UNDER the Resource Management Act 1991 (RMA)
IN THE MATTER of the Far North Proposed District Plan - Hearing 15D:
Rezoning Kerikeri-Waipapa

**STATEMENT OF REBUTTAL EVIDENCE OF ROBERT MATTHEW WILLIAM
(LADDIE) KUTA ON BEHALF OF KIWI FRESH ORANGE COMPANY
LIMITED**

FLOOD MITIGATION

Figure 1: Low Order Flood Frequency for Kerikeri River near property of interest

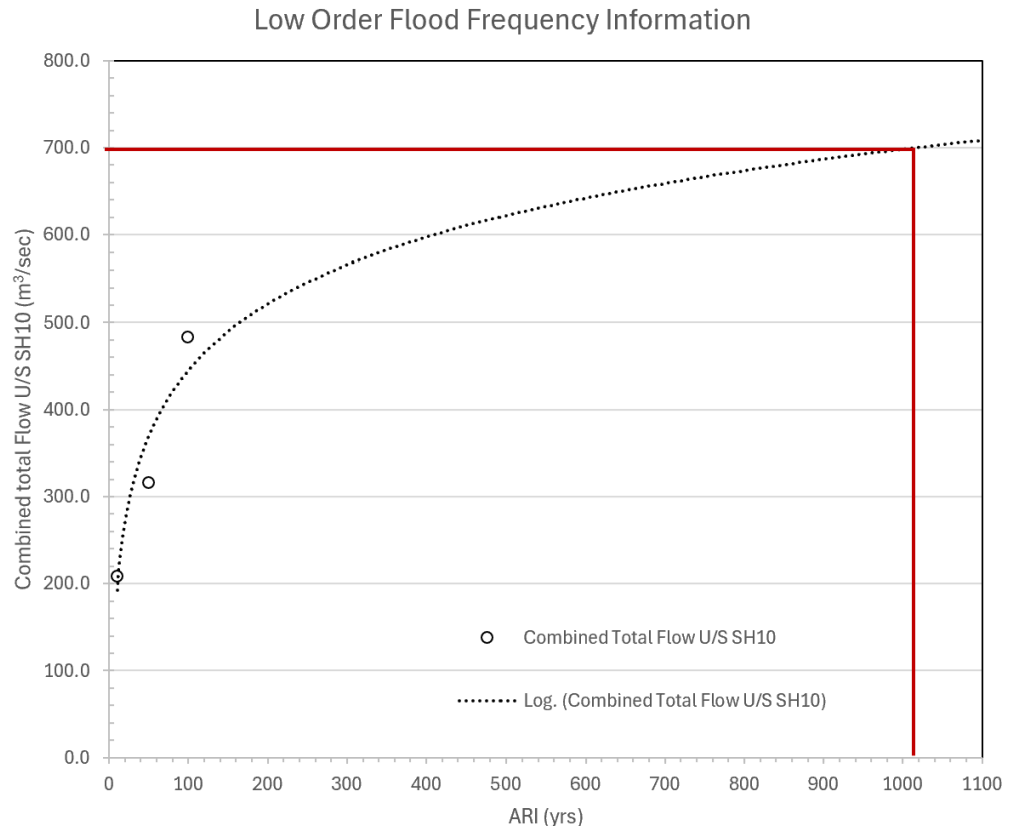
- 23 In response to Mr. Rix's point 5.22 – The 1% AEP flood was used for the maximum design conditions as this was the information available from NRC at the time. I agree with Mr. Rix that an understanding of how the site would behave during over design events is important, as this is the more common practice we are adopting in a changing climate. Although over design modelling has not been completed to date, a low order over design estimate is provided in Figure 1 overleaf:

- 24 This suggests a low order estimate of a 0.1% AEP combined total flow upstream of SH10 to be in the order of 700m³/sec. This would equate to an additional 200m³/sec going down the property's floodway. The velocities in the floodway are largely dictated by the floodway's grade with an average of 2m/sec, which would somewhat remain the same in the over design event. With an approximate floodway width of 100m this would equate to an additional depth of approximately 1m above the 1% AEP level that is illustrated throughout the current evidence. Again, since much of the land rises away from the floodway, this could be managed with raised land married into the up-sloping land outside the floodway. This above information is for context only and would need to be proven through a technical peer reviewed modelled design at a resource consent stage.

- 25 The estimate I have provided for overdesign is in my opinion on the conservative side and would still be possible to provide flood protection; however, keeping stopbanks out of the design is desirable and presence of bedrock could put more need on stopbanking/raised land. Further modelling of overdesign events during resource consent stage would be able to refine this amount of extra freeboard required for these less frequent extreme events.
